**City of Portland, Oregon**  
**Bureau of Development Services**  
**Land Use Services**  
FROM CONCEPT TO CONSTRUCTION

**Date:** June 18, 2018  
**To:** Ryan Miyahira, ANKROM MOISAN ARCHITECTS, INC  
**From:** Benjamin Nielsen, Land Use Review  
**Re:** 18-118843 DA – Grand Ave Mixed-use Apartments  
Design Advice Request Summary Memo – June 7, 2018

This memo summarizes **Design Commission** design direction provided on June 7, 2018.

GROUND FLOOR PLAN - CURRENT SCHEME

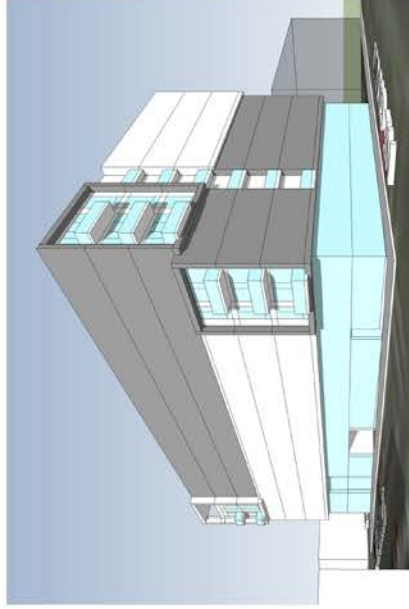
Revisions shown to the ground floor plan were found to meet the guidelines quite well overall. The proposed upper stories are improving, though Commissioners still expressed concern that the addition of windows may compromise or complicate the formal composition.

- All commissioners said the revisions to the ground floor were very good.
- Commissioners stressed that the lobby should be addressed in terms of scale and as a major entry into the building.
  - The leasing office should be incorporated as part of the lobby, particularly as viewed from the outside.
- Commissioners thought that pulling the ground floor massing back from the north lot could work well. Be sure that the space created is safe and controlled.
